CITY of NOVI CITY COUNCIL

**Agenda Item 2
August 13, 2007**

Consideration of the request of Hobbs and Black for Gold's Gym for Preliminary Site Plan approval of a 10,480 square foot addition and façade modification to the existing Fountain Walk Shopping Center. The subject property is located in Section 15, south of Twelve Mile Road, west of Donelson Drive, in the Twelve Mile Crossing at Fountain Walk development in the R-C, Regional Center District.

Gold's Gym
SP07-31

PROPOSED REVISED SITE PLAN

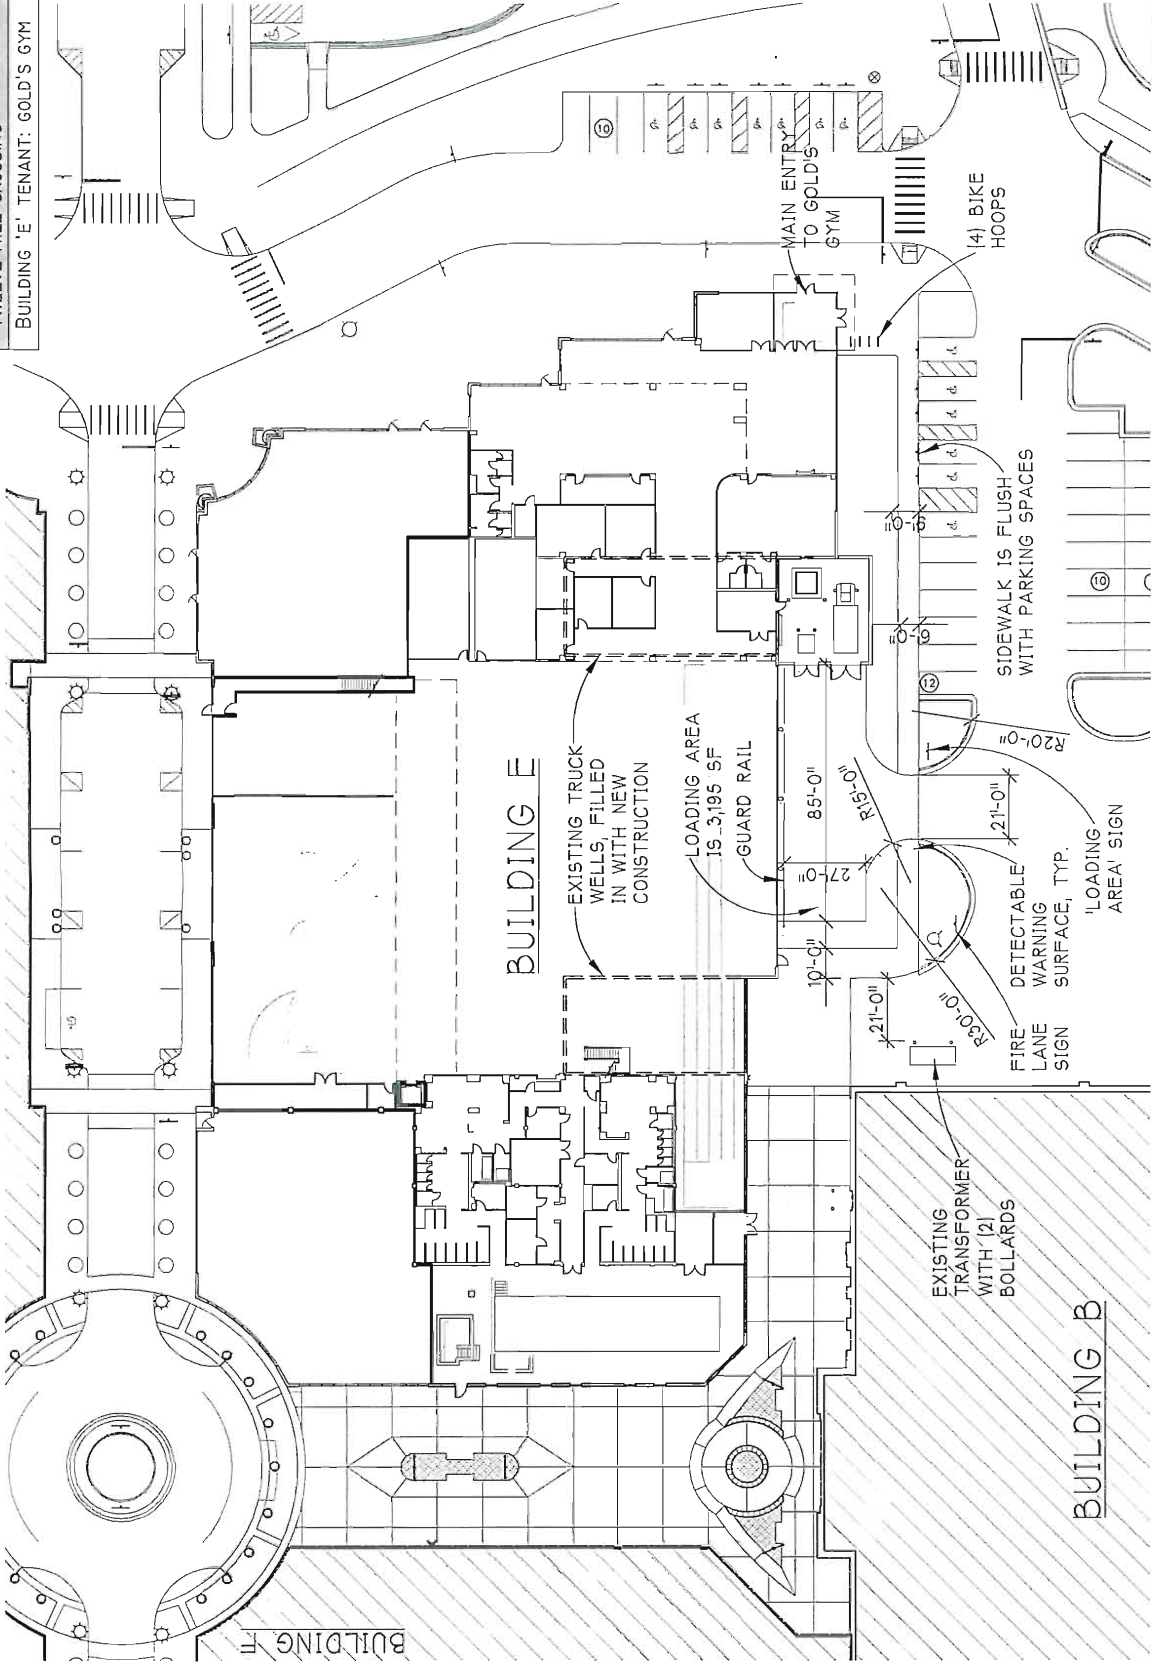
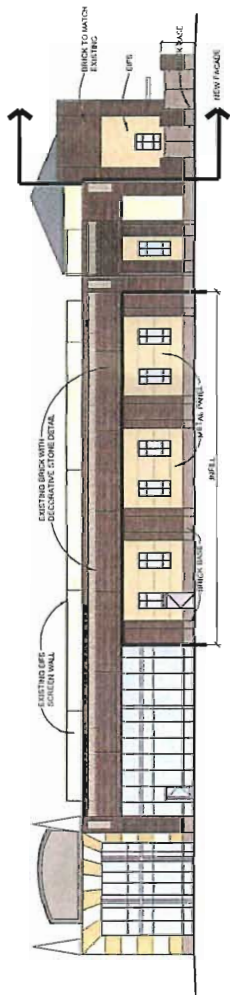
Please see attached reduced version of the revised site plan and building elevations. The City's Traffic Consultant and Staff have reviewed this modified proposal and recommend approval of the changes. Please note that the fire access remains the same as approved with the Phase III plan.

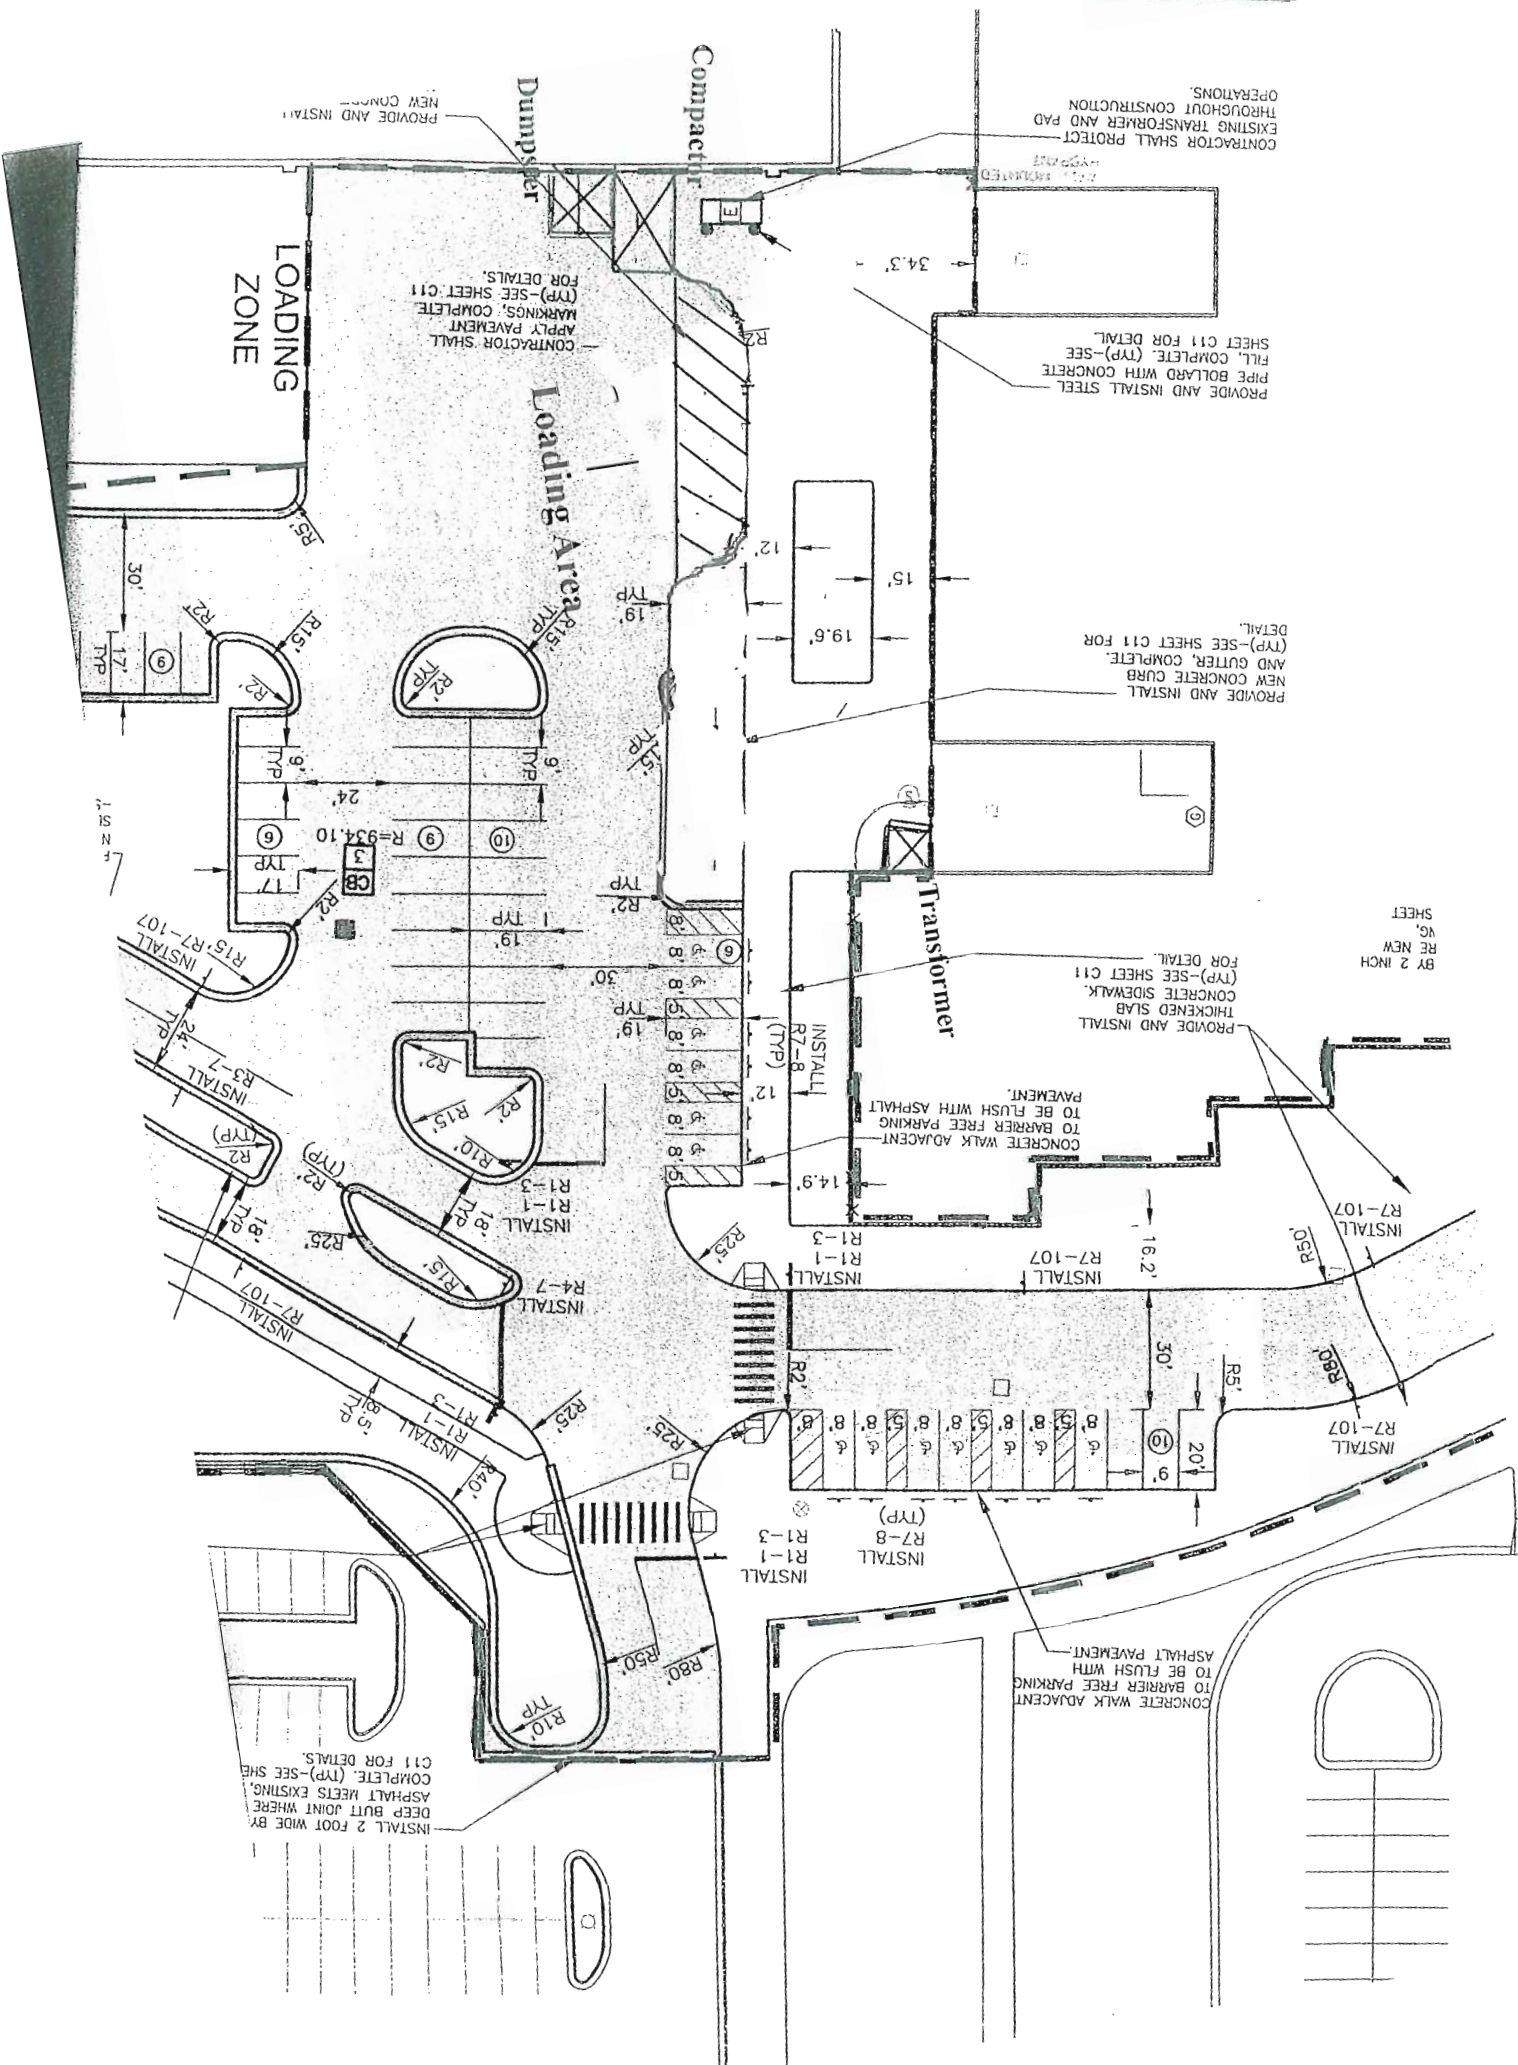
4. We have also briefly reviewed the concept plan provided by Mark Spencer, the City of Novi Planner for the proposed development. This concept plan is drawn for the east of the proposed building with regards to the loading areas and refuse locations. We find the site plan prepared by Hobbs + Black Associates, Inc. and the concept plan provided by Mark Spencer to be equally safe and efficient with respect to the refuse pick-up and the loading area. However, the concept plan prepared by the City planning staff consolidates the refuse area at one location near existing transformer and pad. Although this plan eliminates eight (8) parking spaces, it provides efficiently maneuverable loading area. We also recommend for the concept plan that a screen wall should be provided around the proposed refuse area and longer loading zone should be provided by extending it to further north. The sketch of the concept plan by the City's planning staff is attached with this review.

ARCHITECTURAL SITE PLAN
SCALE - 1"=80'

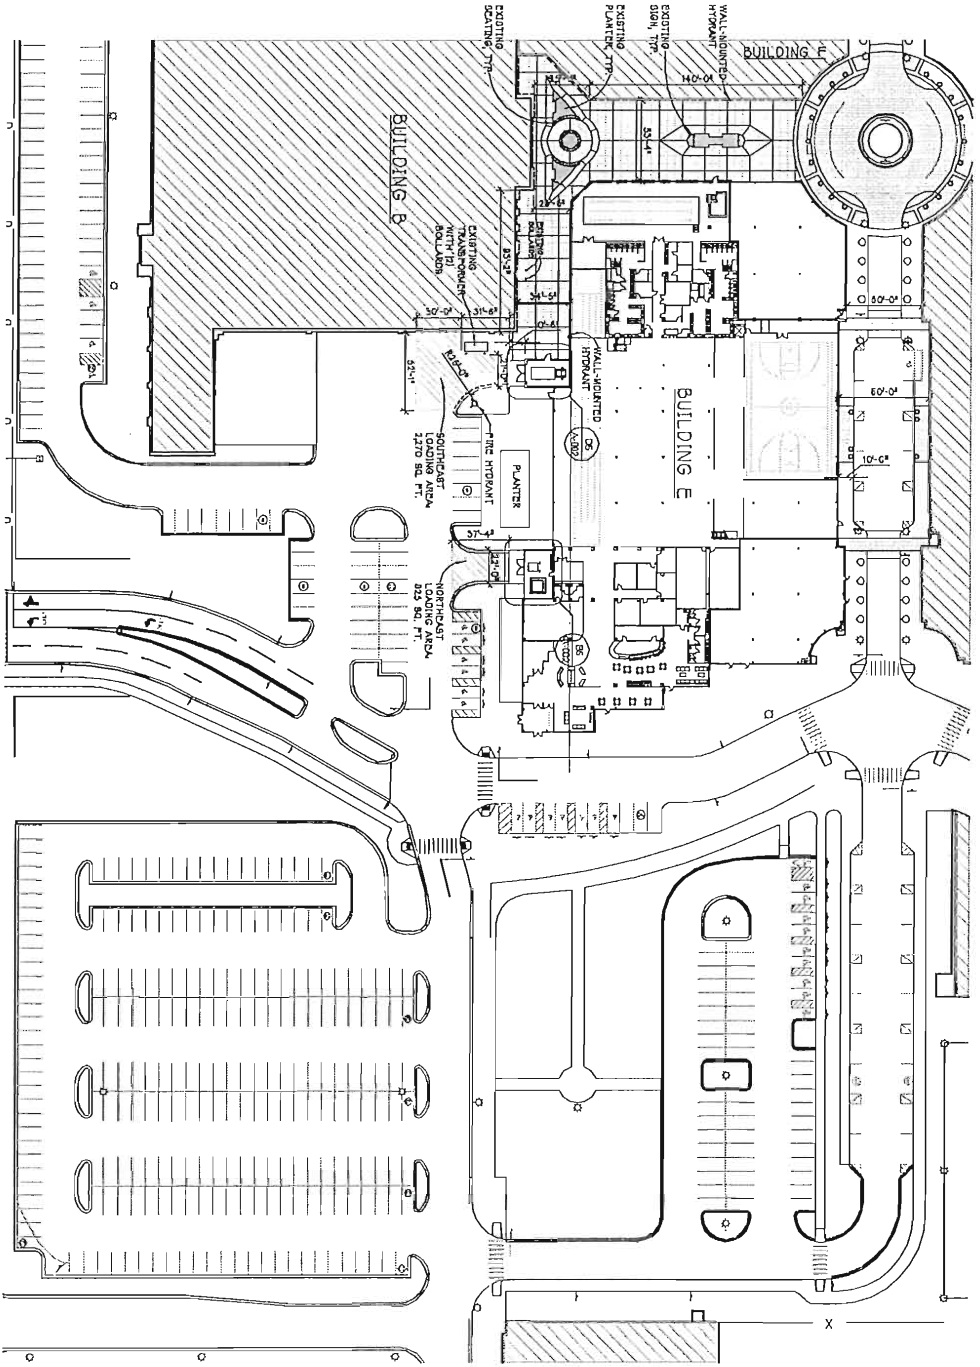
- We note that a landscaping island is erroneously denoted as "loading area" on sheet A-100. Such anomaly should be corrected.
- The parallel parking spaces west of the proposed development are marked on sheet A-002 as loading zone adjacent to the building. Such loading zone is redundant, would detract from parallel on-street style parking. The City of Novi Zoning Ordinance Section 2507.4 clearly prevents such practice. Hence, such loading zone should be eliminated from the plan.
- We do not believe that the north loading zone on the east side of the proposed development is suitable for vehicles larger than the step vans. The City of Novi Zoning Ordinance Section 2507.2 states that within RC district, loading space shall be at a ratio of ten (10) square feet for each front foot of the building. Such requirement should be checked and implemented for this loading zone.

- 3) We have added a larger loading area on the east side of the building (see sketch A-0). Together the loading areas provide more than the required 3,150 square feet.

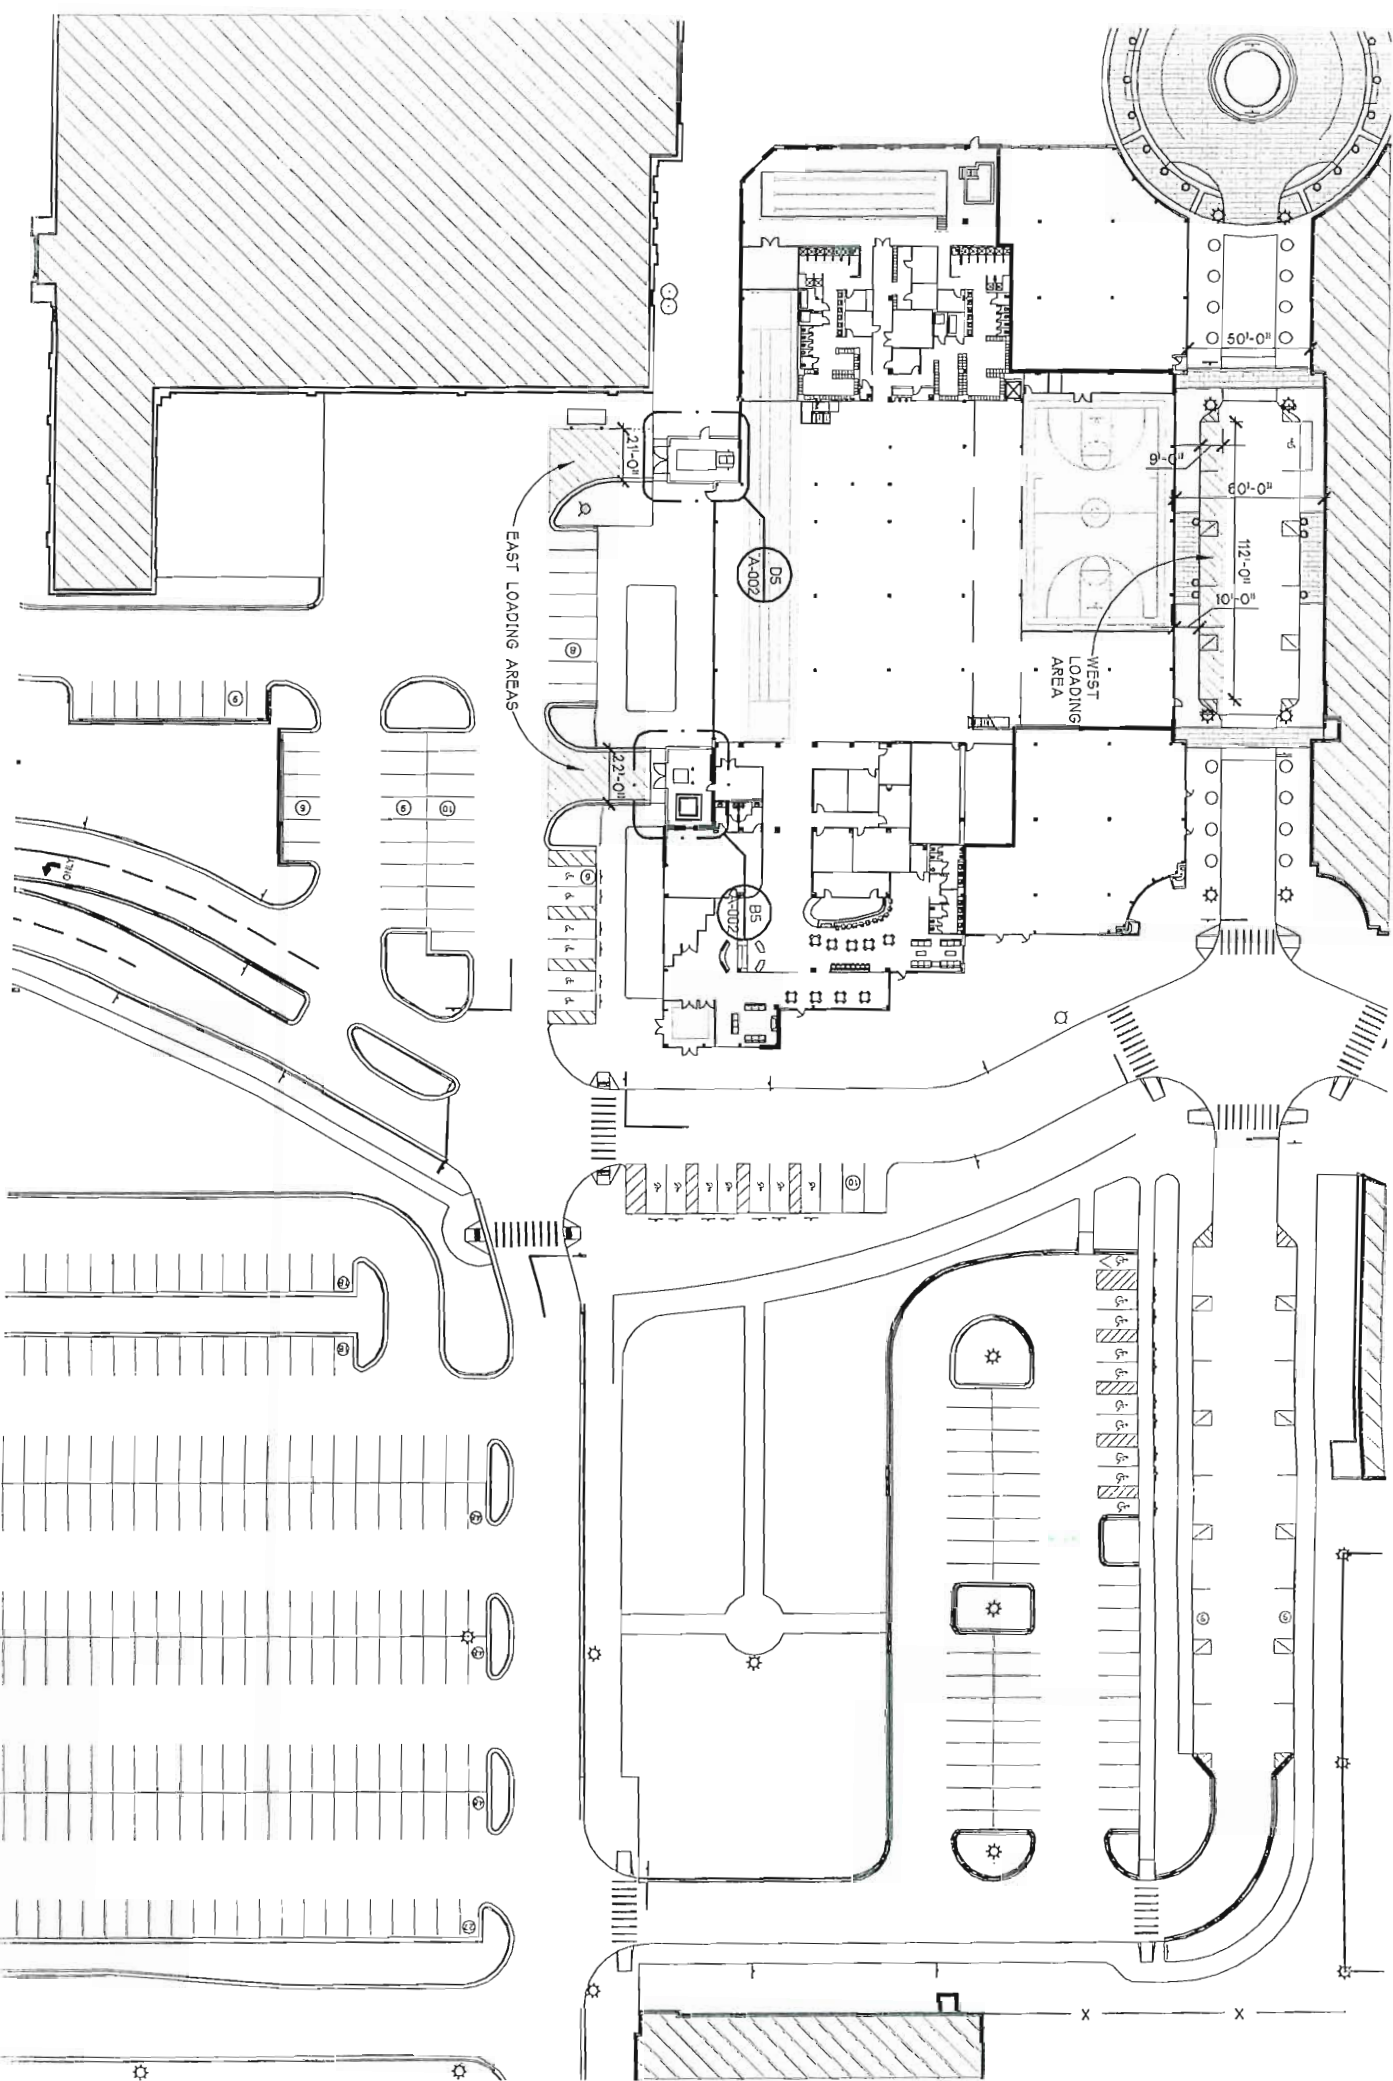
We have a solution for the trash enclosure (see attached) that should address all of the concerns on operations, appearance, pedestrian walkways, and emergency access to the pedestrian concourse. We lost 2 parking spaces in this design, but the net total on site is well above requirements. This plan includes trees and landscaped areas to match the amounts previously approved for Phase III.
